Duke Power Company
A Duke Energy Company
McGuire Nuclear Station
12700 Hagers Ferry Road
Huntersville, NC 28078-9340

Subject: McGuire Nuclear Station, Units 1 and 2
Docket Nos. 50-369 and 50-370
Supplement to Proposed Revision to Technical
Specifications (TS) Submittal dated February 14, 2001
TAC Numbers MB1261 and MB1262

DUKE POWER COMPANY
MCGUIRE NUCLEAR STATION
ATTACHMENT 1

DUKE POWER COMPANY
MCGUIRE NUCLEAR STATION
ATTACHMENT 2

Figure 3.4.3-1

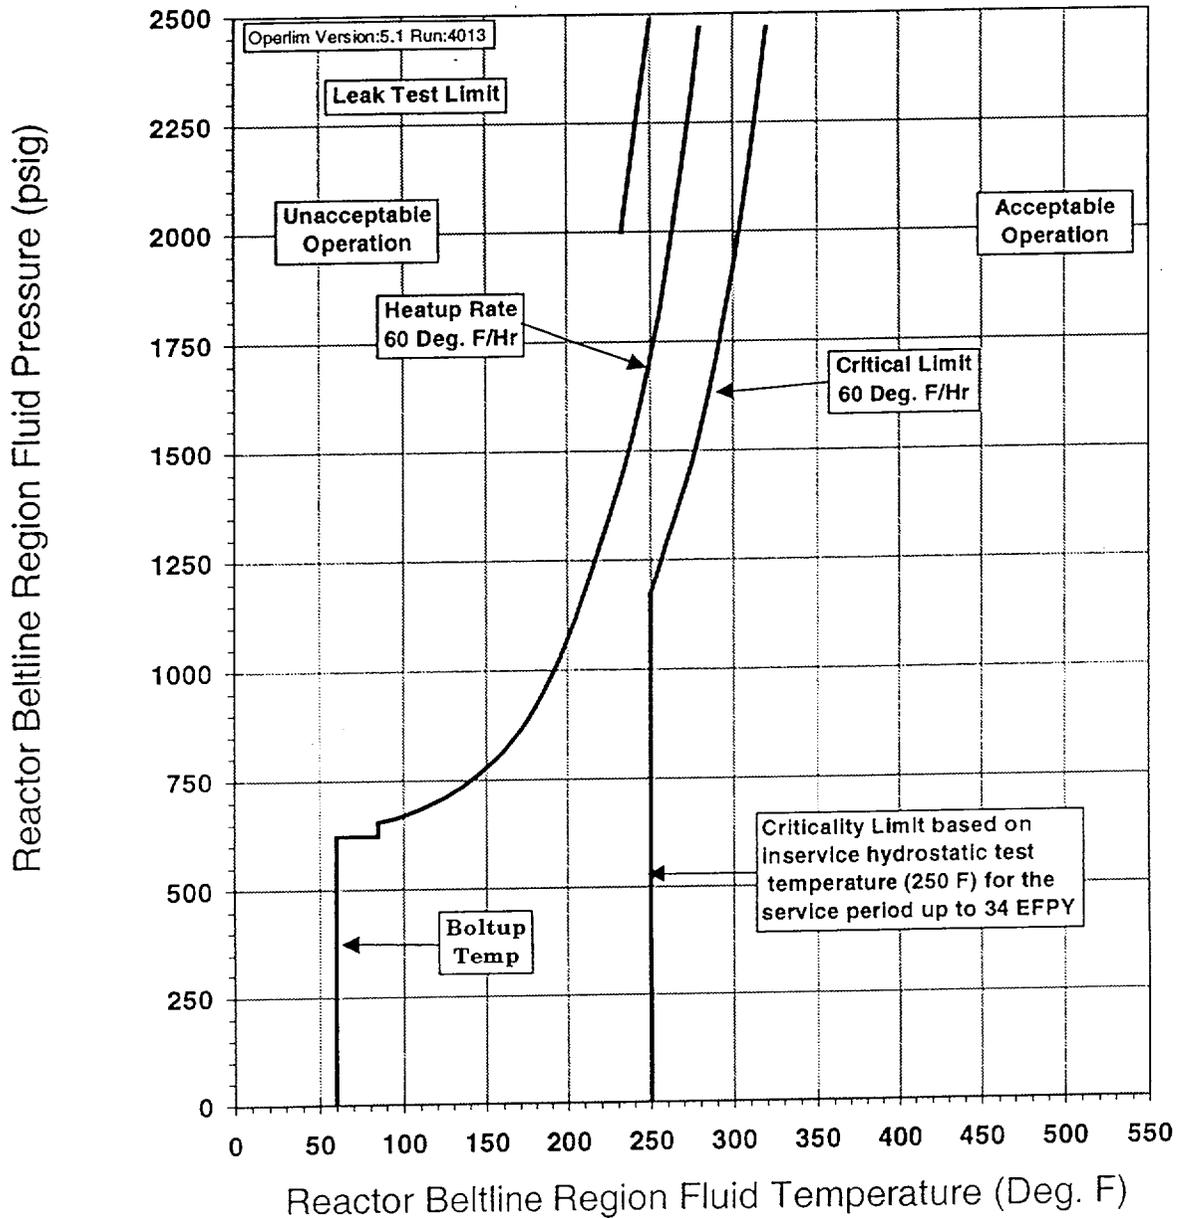
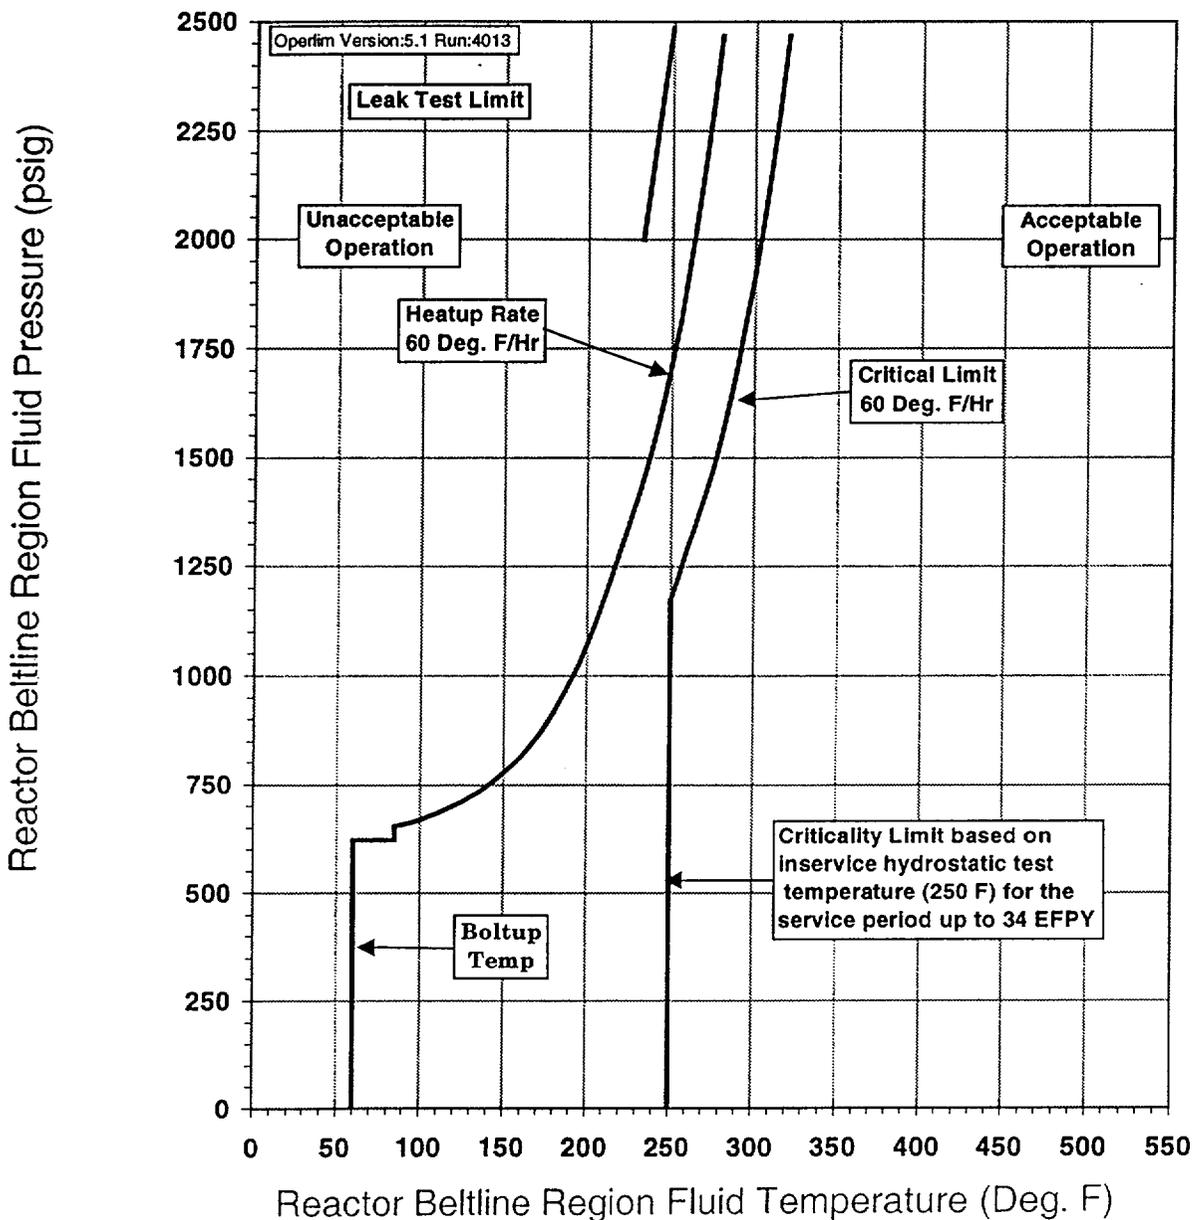
1/ In Attachment 1 of the submittal, replace Pages 3.3.2-11, 3.3.2-12, B 3.3.2-16, B 3.3.2-17, B 3.3.2-18, Figures 3.4.3-1, 3.4.3-2, 3.4.3-3 and 3.4.3-4 with the corresponding pages as included in Attachment 1 of this supplement.

2/ In Attachment 2 of the submittal, replace Figures 3.4.3-1, 3.4.3-2, 3.4.3-3 and 3.4.3-4 with the corresponding figures as included in Attachment 2 of this supplement.

Revision 1 of the WCAP reports corrects the error detected in the computer program used to generate the heatup and cooldown curves. This correction resulted in changes to the heatup curves (Figures 3.4.3-1 through 3.4.3-4) in the submittal. The cooldown curves were not affected. The revised heatup curves are slightly more restrictive but do not affect Duke Energy's low temperature overpressure protection analysis. The revised WCAPs only affect the heatup curves. Pages 3.3.2-11, 3.3.2-12, B 3.3.2-16, B 3.3.2-17, and B 3.3.2-18 in Attachment 1 of the submittal are replaced with corresponding pages to reflect the latest approved version of the McGuire Technical Specifications and corresponding Bases. The remaining attachments of the original submittal including the technical justification, no significant hazards consideration evaluation and environmental impact assessment remain valid for NRC review and approval.

FIGURE 5-1 McGuire Unit 1 Reactor Coolant System Heatup Limitations (Heatup Rate of 60°F/hr) Applicable to 34 EFPY (Without Margins of for Instrumentation Errors)

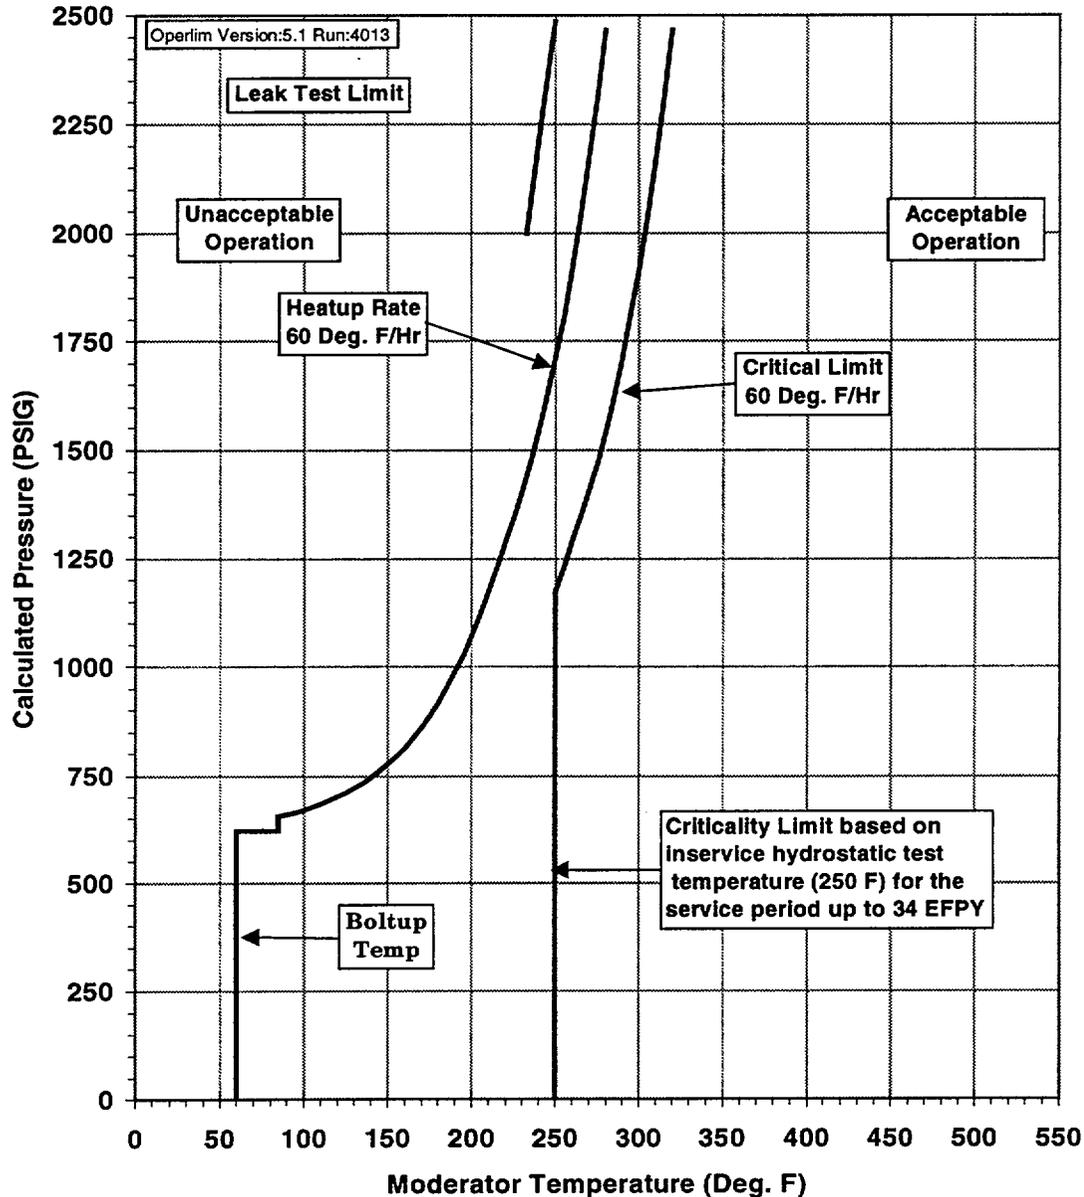
An error was detected in the "OPERLIM" Computer Program that Westinghouse uses to generate pressure-temperature (PT) limit curves. This error potentially effects the heatup curves when the 1996 Appendix G Methodology is used in generating the PT curves. It has been determined that WCAP-15192 Rev. 0 was impacted by this error. Thus, this revision provides corrected curves from WCAP-15192 Rev. 0.

Note that only the heatup curves and associated data point tables have changed. The cooldown curves and data points remain valid and were not changed.
